ADDENDUM NO. 2

- A. Date: 19 March 2013
- B. From: Bahr Vermeer and Haecker Architects, Ltd.
- C. To: Prospective Bidders.
- D. Project: Lexington Public Schools Lexington Middle School and Community Recreation Facility Addition 100% Contract Documents
- E. This addendum is issued by the Architect to all bidders of record prior to receipt of proposals. Bidders shall acknowledge receipt of this addendum by so indicating on the Bid Form. Failure to do so may subject Bidder to disqualification.
- F. All information and instructions given herein shall become a part of the Contract Documents.

ADDENDUM # 2

PROJECT Lexington Middle School & CRF Addition

SHEET
M2.2C
ATTACHMENT NO.

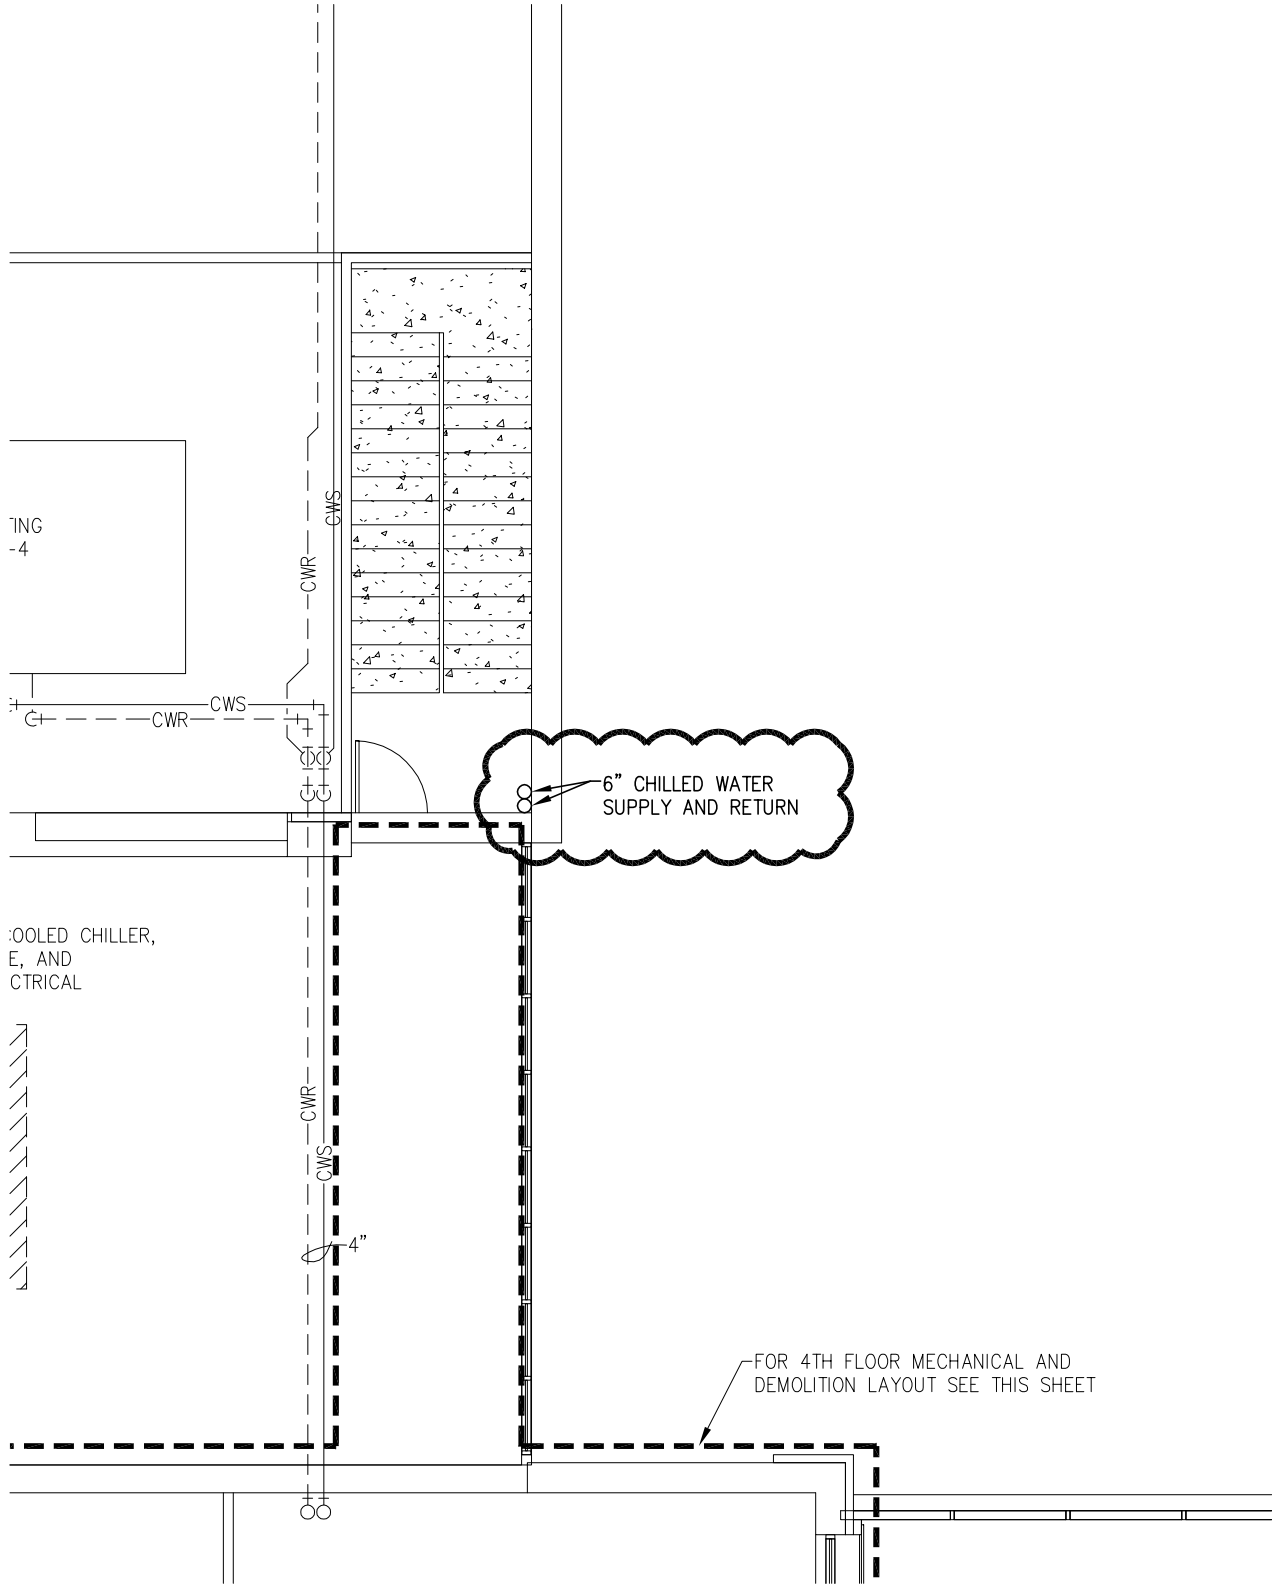
8. Sheet M2.2C Second Floor Plan – Area C - Mechanical
 - A. See sheet M2.2C-1 for changes to the mechanical Plan.
9. Sheet M2.3A Third & Fourth Floor Plan – Area A – Mechanical
 - A. See sheet M2.3A-1 for changes to mechanical plan.
 - B. See sheet M2.3A-2 for changes to mechanical plan and added general notes and added sheet notes.
10. Sheet M3.1A First Floor Plan – Area A - HVAC
 - A. See sheet M3.1A-1 for changes to the HVAC plan and added general note and added sheet note number 22.
11. Sheet M3.2A Second Floor Plan – Area A - HVAC
 - A. See sheet M3.2A-1 for changes to the HVAC plan and added sheet note number 5.
 - B. See sheet M3.2A-2 for changes to the HVAC plan.

M2.3A

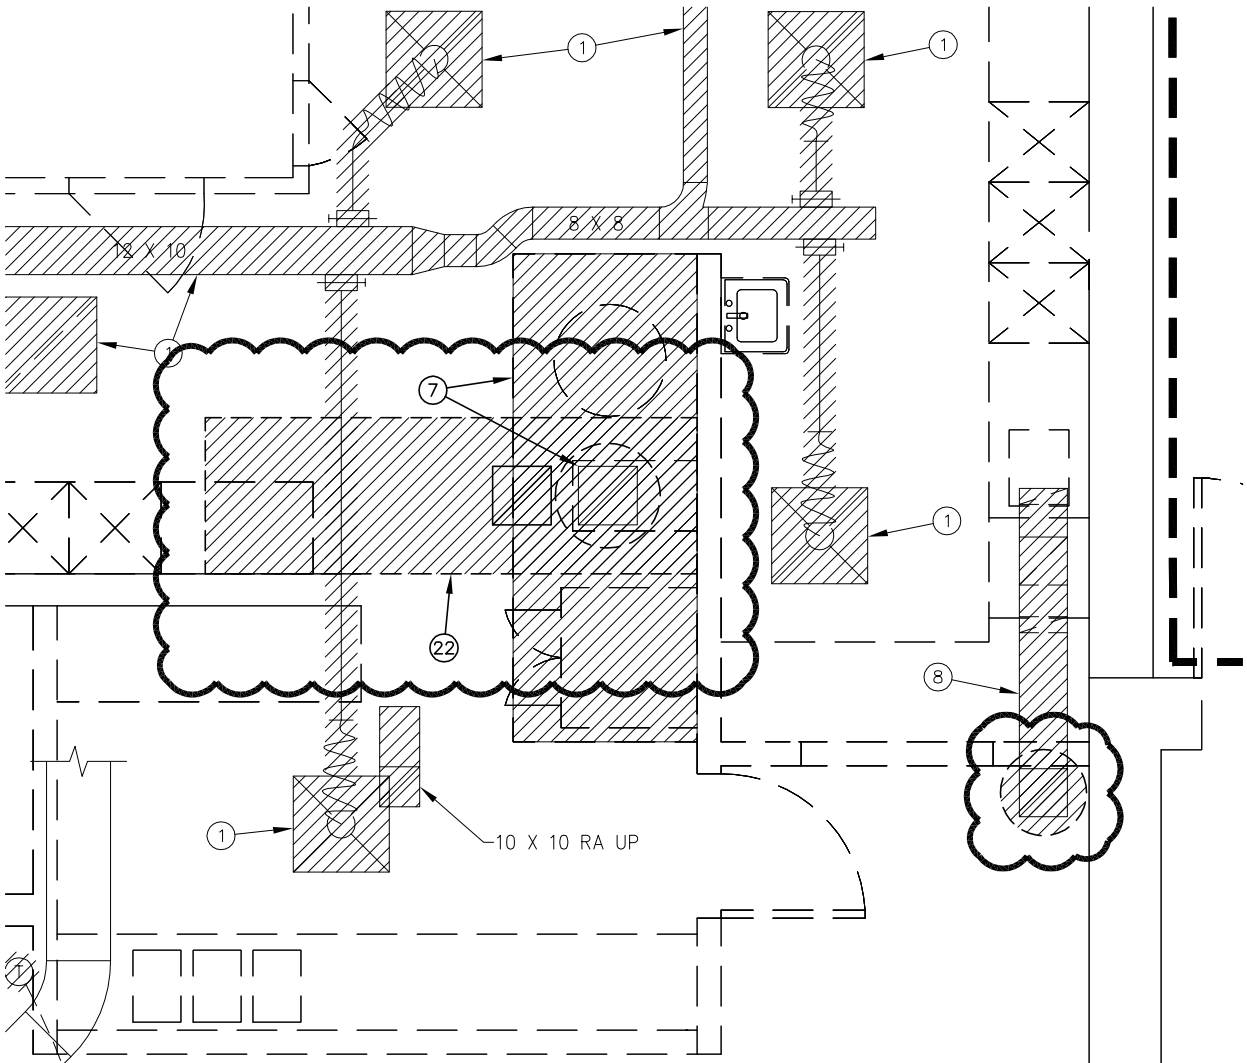
- A. RETURN KITCHEN HOOD, FIRE SUPPRESSION SYSTEM, EXHAUST FANS, MAKE-UP AIR UNIT AND CEILING UNIT HEATER BACK TO OWNER.

SHEET
M3.2A
ATTACHMENT NO.

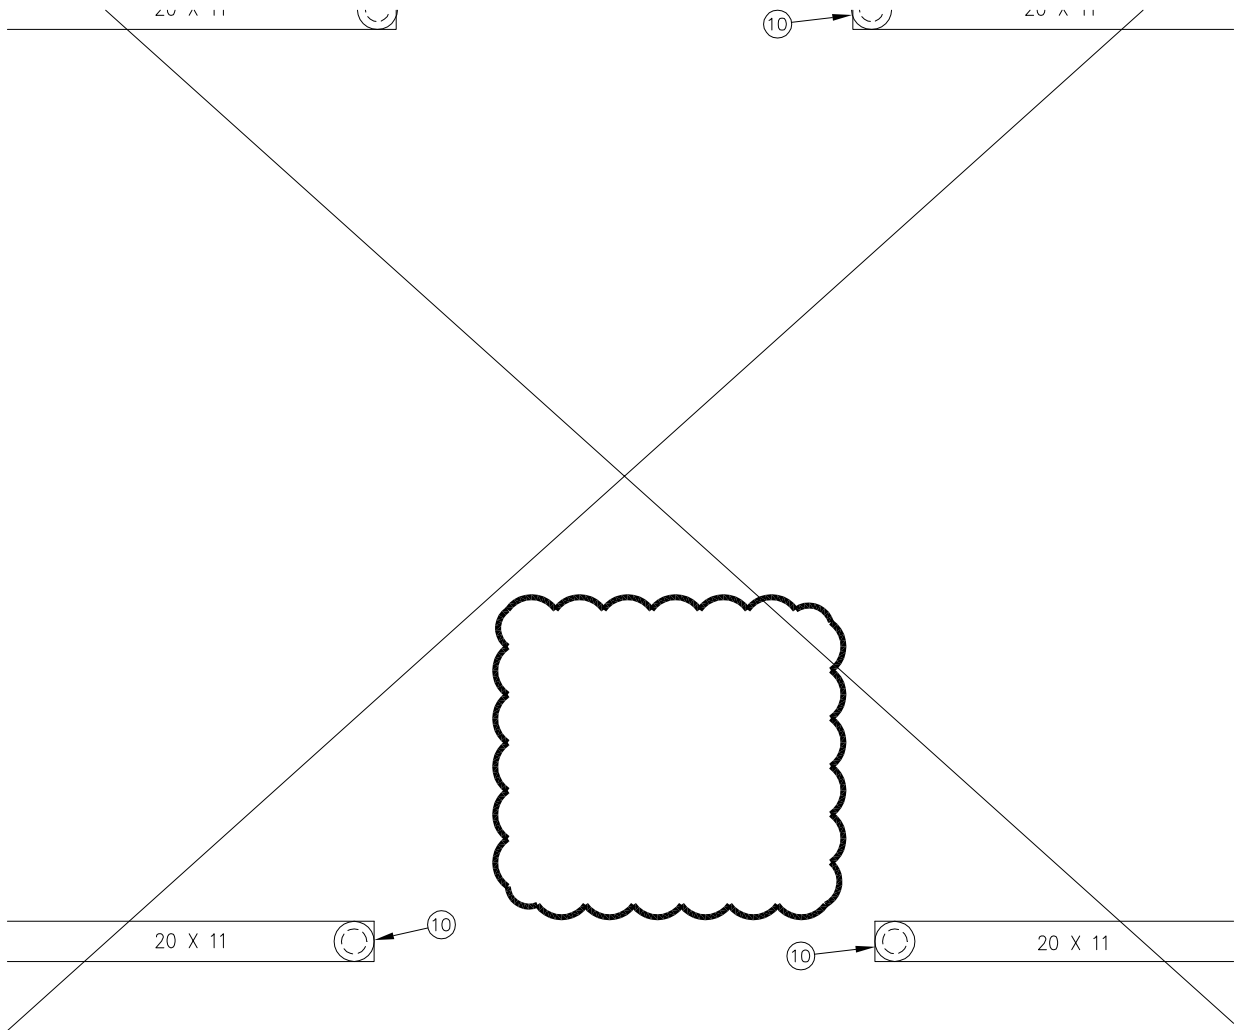
5. REMOVE EXISTING RELIEF HOOD, DAMPER, DRIP PAN, ASSOCIATED HARDWARE AND CONTROLS.

03/19/13
SHEET E1.1A
ATTACHMENT NO. 1
BJF

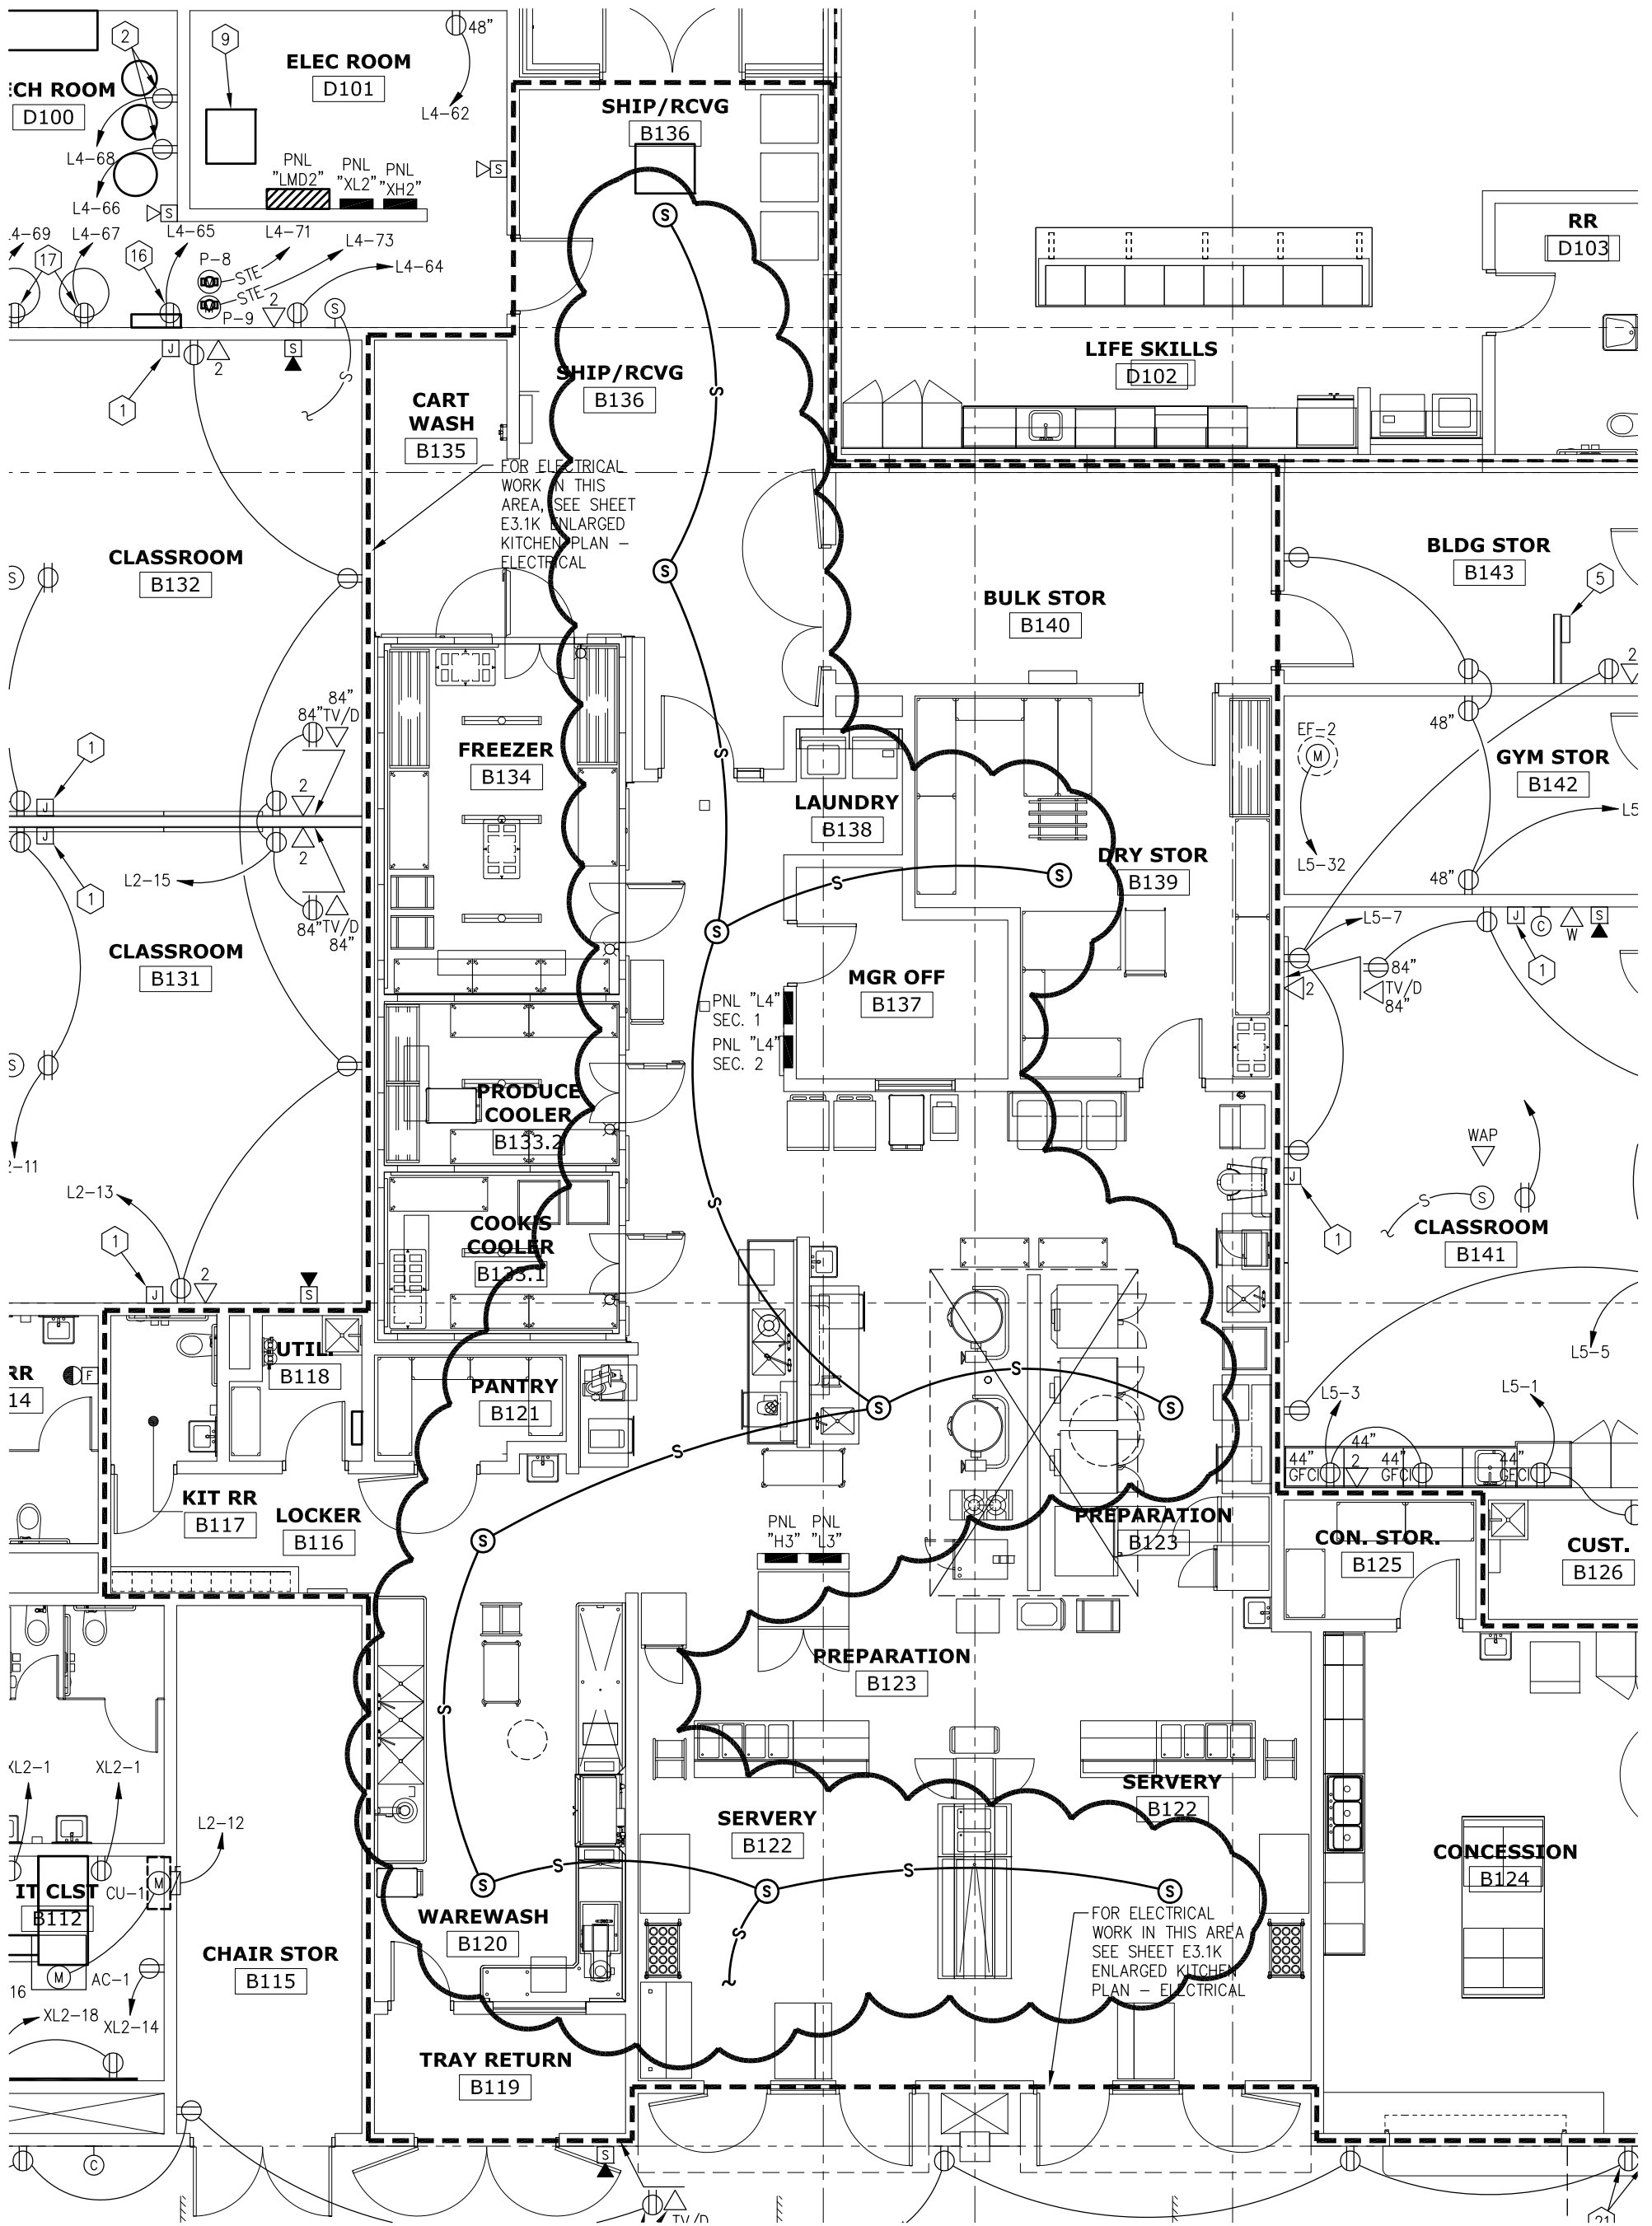
1. Sheet ME1.0
 - A. This sheet is for reference only and the work has been bid and completed.
2. Sheet E1.1A
 - A. See attached drawing E1.1A #1 for work in the existing gymnasium.

11. MOTORIZED BLEACHERS TO BE RELOCATED TO NORTH WALL. REMOVE 30A DISCONNECT AND CONDUIT BACK TO ENTRY. EXTEND CIRCUIT TO NORTH WALL AND DOWN TO RELOCATED DISCONNECT SWITCH. RECONNECT BLEACHERS TO DISCONNECT.
12. RUN CONDUIT UP AT CEILING LEVEL THEN DOWN TO RELOCATED DISCONNECT. CONDUCTORS SHALL BE #8. PAINT CONDUIT TO MATCH EXISTING CEILING AND WALL FINISH.
13. RELOCATED BLEACHERS DISCONNECT.
14. RELOCATE TWO SPEAKER JACKS TO SOUTH WALL. EXTEND CONDUCTORS AS REQUIRED. FIELD VERIFY.
15. RELOCATED SPEAKER JACKS LOCATION.
16. EXISTING SPEAKER LOCATION (APPROX.).
17. REMOVE POWER CIRCUIT TO DIVIDER CURTAIN BACK TO SOURCE.
18. PROVIDE NEW RECEPTACLE AND EXTEND #10 TO NEW PANEL "K", SEE SHEET E3.1A FOR LOCATION. PAINT CONDUIT WHERE EXPOSED.

03/19/13
SHEET E3.1B
ATTACHMENT NO. 1
BJF

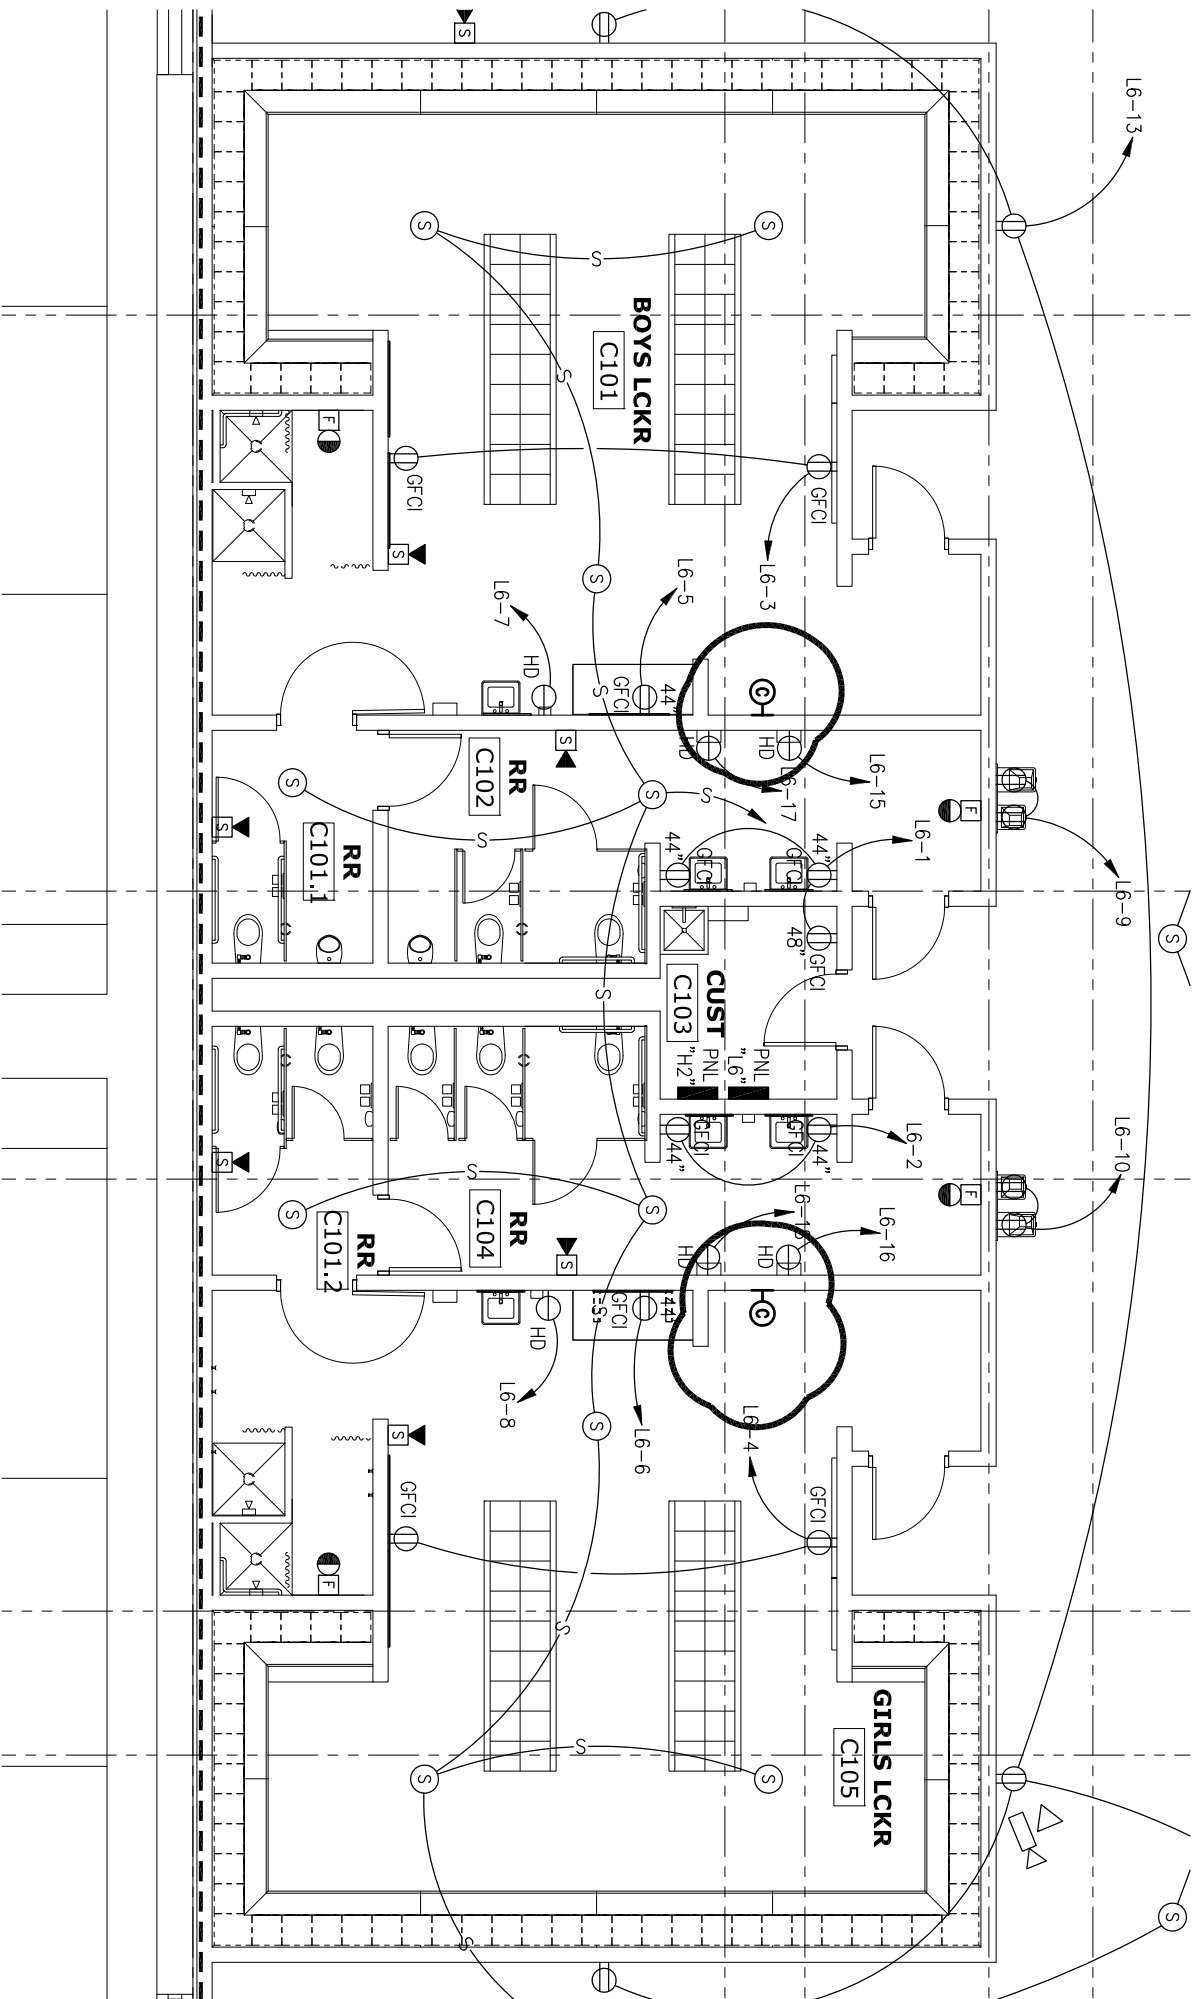
3. Sheet E3.1B
 - A. See attached drawing E3.1B #1 for speakers in kitchen area.
4. Sheet E3.1C
 - A. See attached drawing E3.1C #1 for additional clocks.
